No. 94-3

- A. CYLINDER HEAD BOLT CHANGE**
- B. CYLINDER HEAD TORQUE SEQUENCE CHANGE**
- C. THRU-HULL WATER PICK UP ELIMINATED ON MCM D4.2L**

MCM D4.2L, D3.6L, D3.0L, and MIE D4.2L, D3.6L, 3.0L Diesels

A. CYLINDER HEAD BOLT CHANGE

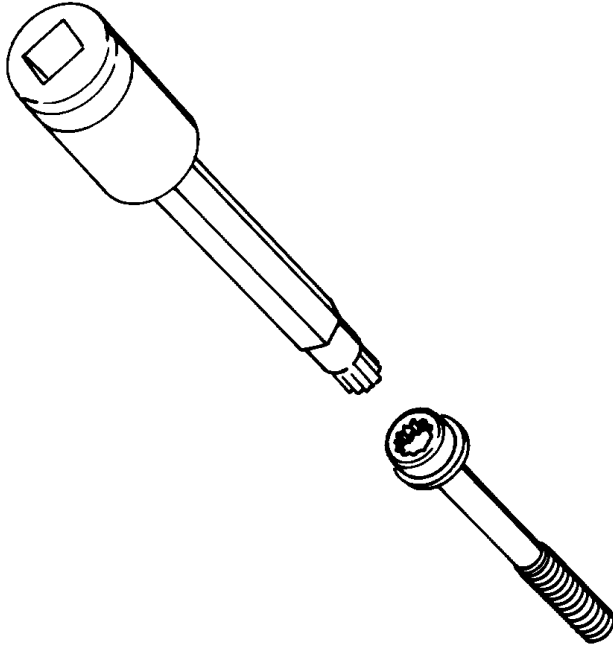
All head bolts have been replaced with new bolts that use a “triple square” head configuration.

There are two head sizes 12mm, and 14mm. These bolts require special triple square drivers. The tool fits into the head of the bolt similar to a hex head driver. The part number for the new Cylinder Head Bolt Service Tool Kit is 806563A 1.

B. CYLINDER HEAD BOLT TORQUE SEQUENCE CHANGE

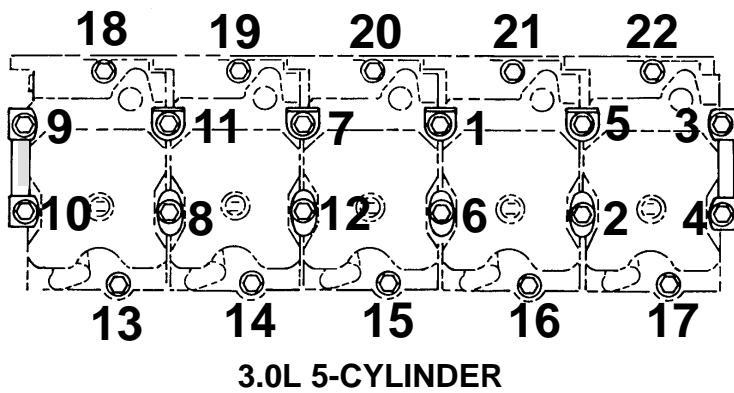
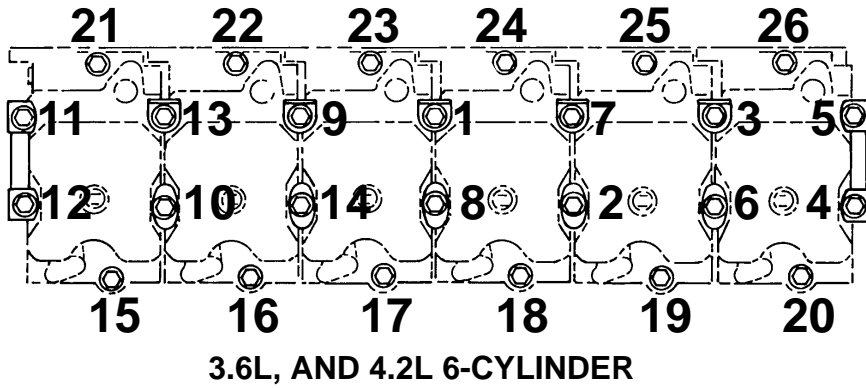
The new cylinder head bolt torque is as follows.
